Nebraska Public Power District

NLS940084
December 23, 1994

Subject: Exemption Request - 10 CFR 50.55a(a)(2)
HPCI Turbine Exhaust Line Pressure Boundary
Cooper Nuclear Station
NRC Docket No. 50-298, License No. DPR-46

COOPER NUCLEAR STATION
NRC DOCKET NO. 50-298
OPERATING LICENSE DPR-46
10 CFR 50.55A EXEMPTION REQUEST
24" HPCI TURBINE LINE TO 10" BRANCH WELD

FIG. 1

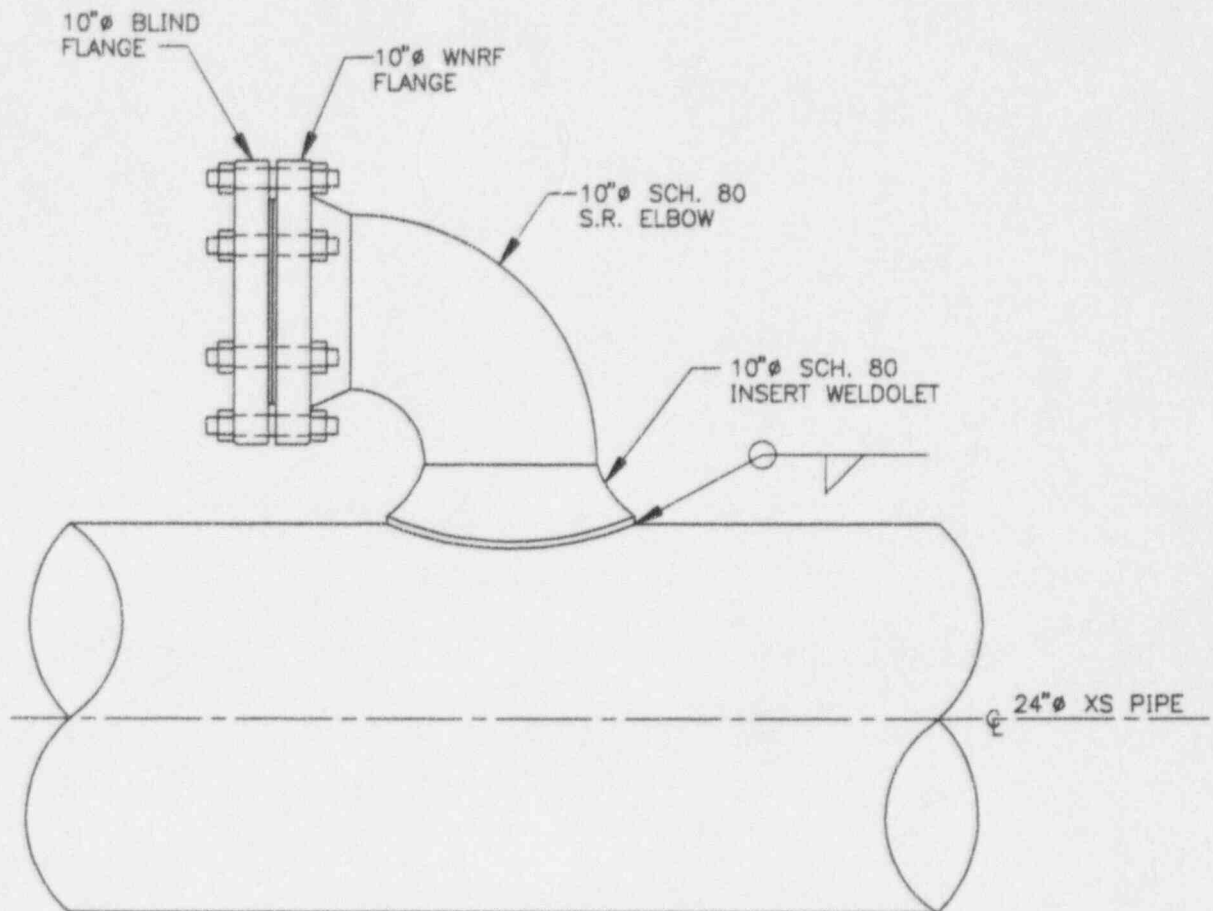
The branch line in question consists of a 24 inch STD by 10 inch SCH 80 insert weldolet (WOL), a 10" Sch. 80 elbow, and a blind flange (see Fig. 1). The branch line is situated on a section of the HPCI exhaust piping located inside of the Torus portion of primary containment and is located within inches of the surface of the Torus water level where the exhaust line enters a submerged steam sparger. The weldolet was installed in 1983, per a design modification for the turbine exhaust line, by welding it to the 24" exhaust pipe with a single fillet weld. This condition was discovered during a recent Quality Assurance (QA) Department review of past QA findings. The weld nonconformance was initially discovered during a 1983 QA finding. However, response to the QA finding only addressed the structural adequacy of the as-left condition and failed to address the Code compliance concern. A Condition Report was initiated to document both the cause and the corrective action for this nonconformance.

As noted previously in this discussion, the subject weld does not meet the specific Section III requirement. However, the District has evaluated this weld and has determined that the underlying safety and function of the HPCI turbine exhaust line is not degraded, and that the

The conclusion of the evaluation is that the integrity of the HPCI Turbine Exhaust piping pressure boundary at the 24" pipe to 10" WOL weld is acceptable in its current condition. This conclusion is based on the following:

- 1) NDE (i.e., visual and PT) was performed on the weld at the time of installation, and the weld was found to have no surface cracks in the initial or the final weld passes.
- 2) The weld is not subjected to secondary stress loads due to thermal expansion or anchor movements that could result in future crack initiation and/or propagation.
- 3) The primary stresses in the weld are extremely low as shown in the table below.
